Response to the Reviewers' Comments

The authors would like to thank the reviewers for the precious comments and suggestions on the technical contents and presentation of our manuscript “Runtime Power Management of Battery Electric Vehicles for Extended Range with Consideration of Driving Time,” submitted to IEEE Transactions on Very Large Scale Integration (TVLSI.) This revised manuscript has been greatly improved thanks to the reviewers’ invaluable advices. We have revised the manuscript faithfully following the reviewers’s comments. We include the newly added or significantly modified parts in the revised version of the paper also in Response to Reviewers. We highlight the important technical content changes and set those parts in a red color in the revised paper.

Fig. 2: (a) Range-speed experimental data for Chevrolet Bolt [36] and (b) comparison with simulation results of the proposed EV power model.

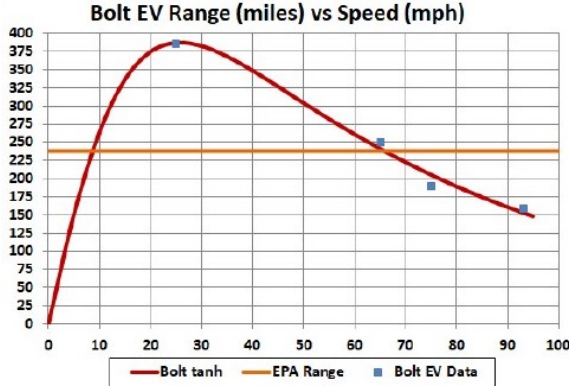
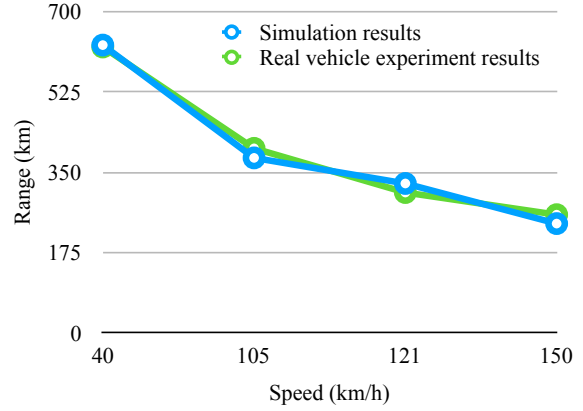
R1-C2 It is not clear how to validate the power model of EV. As the author mentions that accuracy of power model is quite important, it is good to see the power model in this paper can be validated by some real measurement results.

We further evaluate the model accuracy with the range-speed real vehicle experiments as shown in Fig. 2(a) to confirm the derived power models are close enough to the real vehicle measurement data [32], [33], [34], [35], [36]. We refine the coefficients until all the available data values match well.

As a result, the derived EV power model well matches with the range-speed experimental data as shown in Fig. 2(b) as well as the top speed and maximum acceleration setting the aerodynamic resistance, rolling resistance, curb weight, etc. with the known values. The errors in the range-speed simulation is merely 1.4%, the time for 0-to-100 km/h error is 7.8%, and the top speed error is 3.0%, respectively. We revised the manuscript adding the following paragraph with a new figure in Section III.A on page 3 and 4.

We further evaluate the model accuracy with the range-speed real vehicle experiments as shown in Fig. 2(a) to confirm the derived power models are close enough to the real vehicle measurement data [32], [33], [34], [35], [36]. We refine the coefficients until all the available data values match well.

As a result, the derived EV power model well matches with the range-speed experimental data as shown in Fig. 2(b) as well as the top speed and maximum acceleration setting the aerodynamic resistance, rolling resistance, curb weight, etc. with the known values. The errors in the range-speed simulation is merely 1.4%, the time for 0-to-100 km/h error is 7.8%, and the top speed error is 3.0%, respectively.

Fig. 12: Velocity profile comparison with EDP , E^2DP and E^3DP on Serrano Avenue in Anaheim Hills.

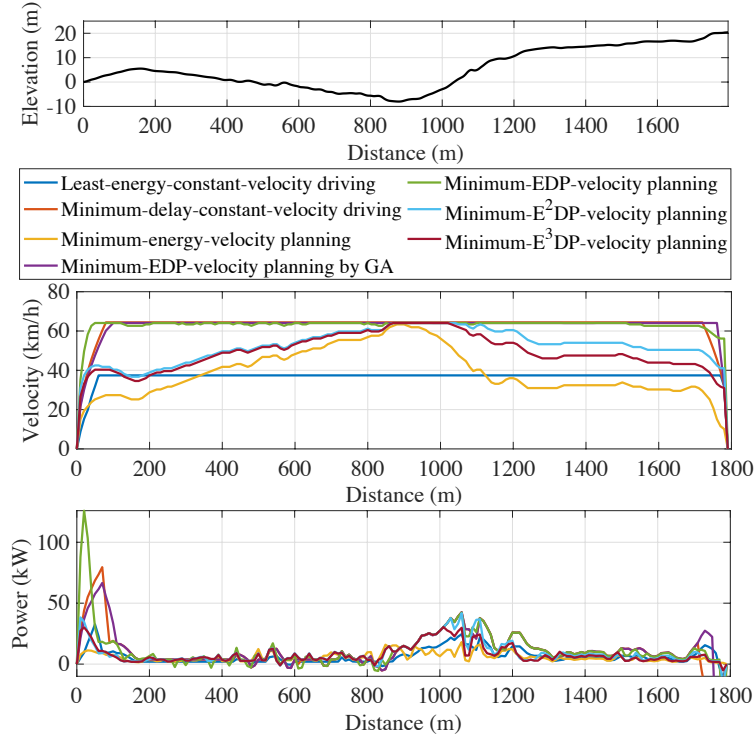
R1-C3 The optimality of the proposed scheduling algorithm is unclear. The author should add several paragraphs to discuss this topic. It is also to see the comparison baseline is well accepted to show the advantage of the proposed algorithm.

We also updated Fig. 12 and Fig. 13:

Fig. 11: Histograms of velocity and acceleration for the proposed energy-aware-velocity planning methods without an acceleration constraint (a) and (b) and with an acceleration constraint (c) and (d), respectively.

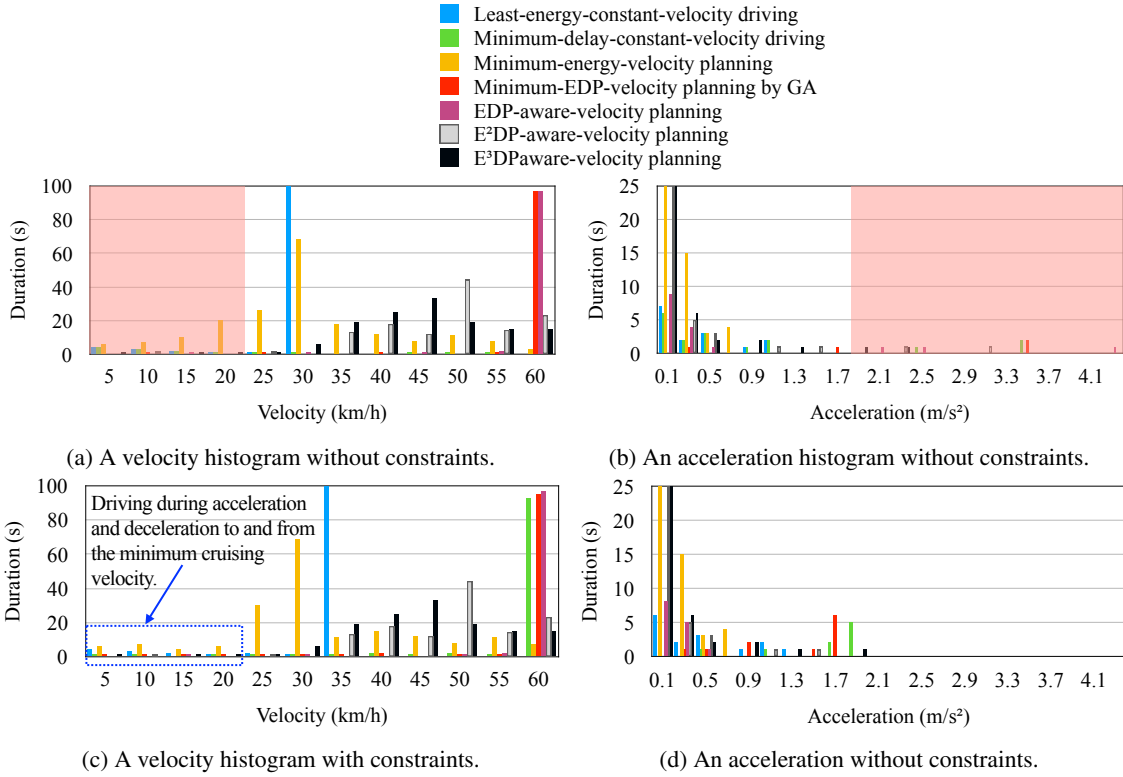
R2-C2 It would be good to have more discussion on the assumptions of the approach and the experiments, e.g., how much can the velocity be changed in practical scenarios without impeding traffic and causing unsafe situations (also depending on the road conditions and whether it is urban or rural environment I suppose). Currently, there only seems to be one constraint on not slower than 10 km/h.

We quantize the velocity and acceleration values and make a histogram to analyze population of velocity and acceleration for the proposed energy-aware-velocity planning methods. Fig. 11(a) and (b) show two histograms of the driving schemes in Fig. 12, which do not have velocity and acceleration constraints. We avoid a cruising velocity lower than 25 km/h and an acceleration higher than 2.0 m/s^2 in this paper without loss of generality. The acceleration of 2.0 m/s^2 is the same as the maximum acceleration of compact cars designed to be used primarily used in urban areas (13 seconds of 0-to-100 km/h time).

Fig. 11(c) and (d) shows the velocity and acceleration histograms with the constraints. Once we run the DP for the first time without constraints, we analyze the histogram, adaptively determine the minimum cruising velocity and maximum acceleration constraints, and run DP again. We keep the same constraints for online recomputation whenever unexpected interrupts occurs.

We quantize the velocity and acceleration values and make a histogram to analyze population of velocity and acceleration for the proposed energy-aware-velocity planning methods. Fig. 11(a) and (b) show two histograms of the driving schemes in Fig. 12, which do not have velocity and acceleration constraints. We avoid a cruising velocity lower than 25 km/h and an acceleration higher than 2.0 m/s^2 in this paper without loss of generality. The acceleration of 2.0 m/s^2 is the same as the maximum acceleration of compact cars designed to be used primarily used in urban areas (13 seconds of 0-to-100 km/h time).

Fig. 11(c) and (d) shows the velocity and acceleration histograms with the constraints. Once we run the DP for the first time without constraints, we analyze the histogram, adaptively determine the minimum cruising velocity and maximum acceleration constraints, and run DP again. We keep the same constraints for online recomputation whenever unexpected interrupts occurs.

Fig. 8: Altitude changes in the real road benchmarks.

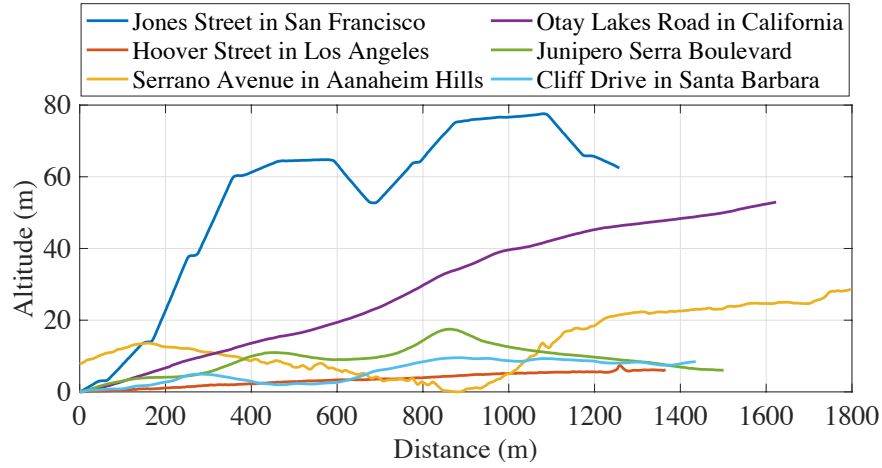
R2-C3 Related to the last point, it would be good to have more discussion on the road benchmarks, e.g., how they are generated and how representative they are. The optimization results significantly depend on road slope. It would be good to use a variety of real road segments for testing.

R2-A3 We appreciate the reviewer's comment. We replaced the previous synthetic road benchmarks with the real road benchmarks. We made six new real road benchmarks from various locations in California. The first three roads are in cities. Jones Street in San Francisco and Hoover Street in Los Angeles are two representative city landscapes such as hills and flat roads, respectively, and Cliff Drive in Santa Barbara is a mixture of those. The second two roads are in mountain areas: Serrano Avenue in Anaheim Hills and Otay Lakes Road in San Ysidro Mountain in California. The last road is Junipero Serra Boulevard connecting San Francisco and San Jose. The details of road data is summarized in Table II, and Fig. 8, which visualize the altitudes of the road benchmarks. We also revised all the associated contents with the new real road benchmarks.

We choose six roads from various locations in California and make real road benchmarks. The first three roads are in cities. Jones Street in San Francisco and Hoover Street in Los Angeles are two representative city landscapes such as hills and flat roads, respectively, and Cliff Drive in Santa Barbara is a mixture of those. The

second two roads are in mountain areas: Serrano Avenue in Anaheim Hills and Otay Lakes Road in San Ysidro Mountain in California. The last road is Junipero Serra Boulevard connecting San Francisco and San Jose. The details of road data is summarized in Table II, and Fig. 8, which visualize the altitudes of the road benchmarks.
